## **Battery and Cable Inspection & Rework**

**Product: Groundsmaster® 4500 & 4700-D**

**May 16, 2007**

## **Battery and Cable Inspection & Rework**

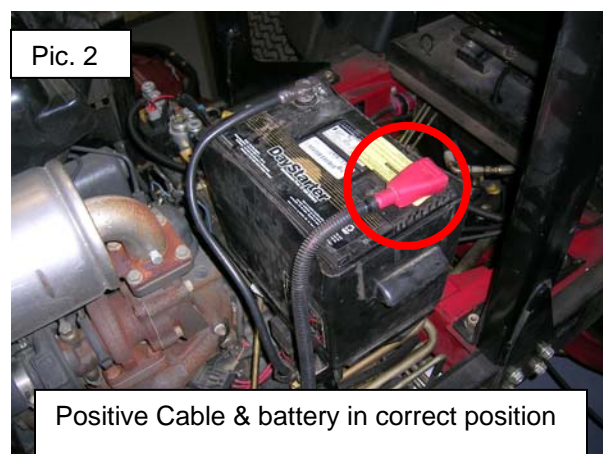
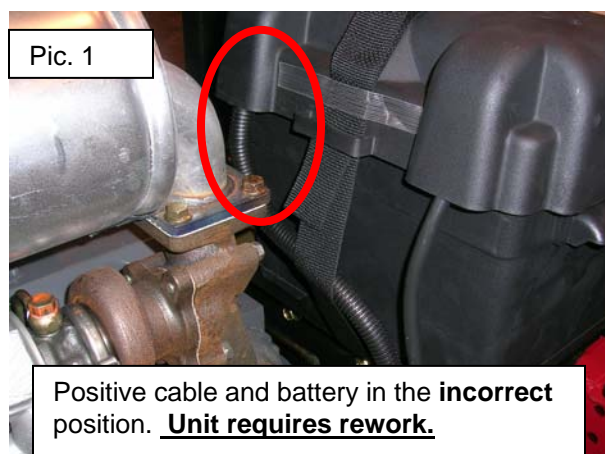
The battery and cables may be installed incorrectly on some Groundsmaster 4500 & 4700-D units. Incorrect installation places the positive battery terminal and cable too close to the Turbocharger & Exhaust Manifold and contact may only be prevented by the battery Case Strap. If the Strap fails (or cable not retained by strap) the positive cable could move and contact the exhaust manifold, resulting in a severe electrical short.

If the battery's positive Cable is positioned next to the Turbocharger & Exhaust Manifold (as shown in Pic. 1 of the Inspection and Rework Instructions) the Battery must be lifted and rotated 180° so the positive post & cable will be away from these components (as shown in Pic. 2). The battery cables then must be repositioned to complete the rework. Secure Battery and Case with original Strap. All machines must be inspected and corrected if the battery and cables are found to be installed in the incorrect position. No additional parts are required to complete this procedure.

1. Raise Hood and visually inspect the Battery Case and Cable positions. If the battery positive cable (corrugated covering) is closer to the Turbocharger/Exhaust Manifold than the negative cable (Pic.1), then proceed with the rework.
2. If the negative cable is closer to the Turbocharger/Exhaust Manifold (Pic. 2) then no rework is required. Machine has been inspected.

1. Remove Battery Case cover.
2. Disconnect negative Battery Cable. Disconnect positive Cable. Place cables off to the sides of the battery case.
3. Lift Battery Case (and Battery) and rotate 180° so the positive battery post is now away from the Turbocharger/Exhaust Manifold (Pic. 2).
4. Remove the retainer bolt and nut that secure the cable clamps at the base of the battery stand (Pic. 3). Swap the clamps from the cables and re-position so the positive cable is now nearest the main Frame of the machine (as shown).
5. Replace the retainer bolt and nut and tighten.
6. Re-install the positive Cable onto the positive Battery Post (in new position). Re-install the negative Cable and tighten post clamps.
7. Re-install the battery cover and secure with original Strap. **Note:** If strap is missing or failed, install replacement Strap (3339-175). Rework complete.
